P5025A-03B-S

Safety Service Note

P5025A Keysight Streamline USB Vector Network Analyzer

“POTENTIAL BURN INJURY (HIGH TEMPERATURE) HAZARD”

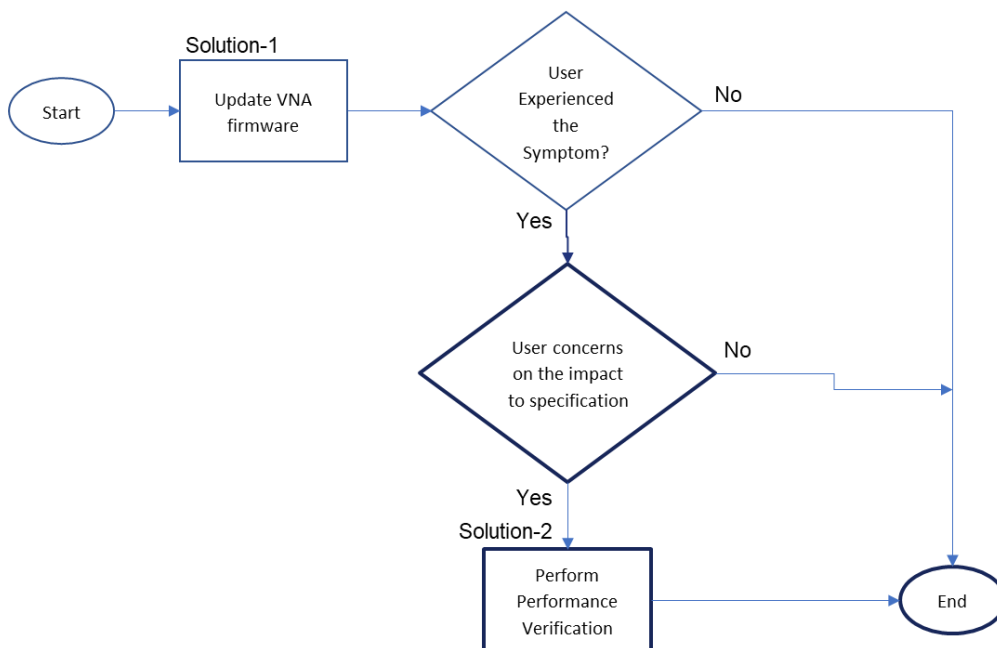
VNA fails to start with the following symptoms.

1. LED indicator (below circle) turns red.
2. cooling fan does not work
3. If user leaves the VNA with this LED indicator red without turning off power switch, it continues to overheat and becomes too hot.

Solution-1: Update VNA firmware by user

Action-1: Updating the firmware eliminates this potential risk of overheating.

1. **Install the latest VNA firmware Rev. A.15.40.13 or newer** on users' controller PC(s).
The latest firmware enhanced the thermal fan control mechanism.
2. Once the latest firmware is installed, proceed with the restart of both **controller PC** and **VNA**.
3. Launch the VNA firmware. Ensure VNA powers up and launches into firmware correctly after firmware update is done.
